BUCIL AMERICAN MOTORCYCLES

B-018 May 13, 1999

SAFETY RECALL CODE 0810 - FRONT ISOLATOR MOUNT SYSTEM

Figure 1. Front Isolator Mount

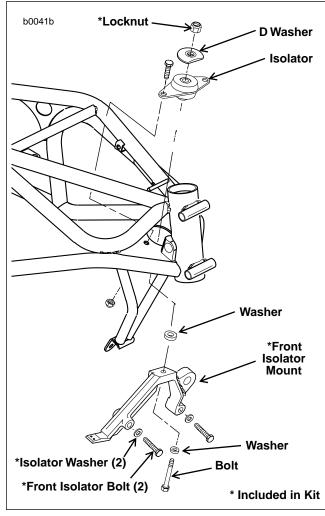
Buell Motorcycle Company has learned that certain 1997 and 1998 Buell motorcycles were built with an isolator mount system that could lose clamp load. Should this condition occur, it may allow the engine to move unexpectedly in the frame and cause an unintended distraction to the operator, which could result in an accident. Accordingly, Buell Motorcycle Company is conducting a voluntary recall campaign to formally recall all potentially affected motorcycles.

This condition will be remedied by replacing the front isolator mount system on all potentially affected vehicles.

- 8. Remove and discard two bolts and washers from left and right side of front isolator mount.
- 9. Remove front isolator mount from left side of motorcycle.

- Clean residual loctite from threads in engine with a suitable nonflammable solvent and dry with compressed air.
- Apply LOCTITE THREADLOCKER 271 (red) to threads of new front isolator mount bolts.
- Apply a thin film of clean HD 20W50 engine oil to both sides of **new** thick washers and to bottom of bolt heads. Exercise caution to avoid mixing oil on washers with loctite on bolts.
- 13. Position new front isolator mount and secure with two new front bolts with new thick washers. Tighten bolts to 60 ft-lbs (81 Nm) initially and then loosen each bolt one full turn. Tighten bolts again to 60 ft-lbs (81 Nm).
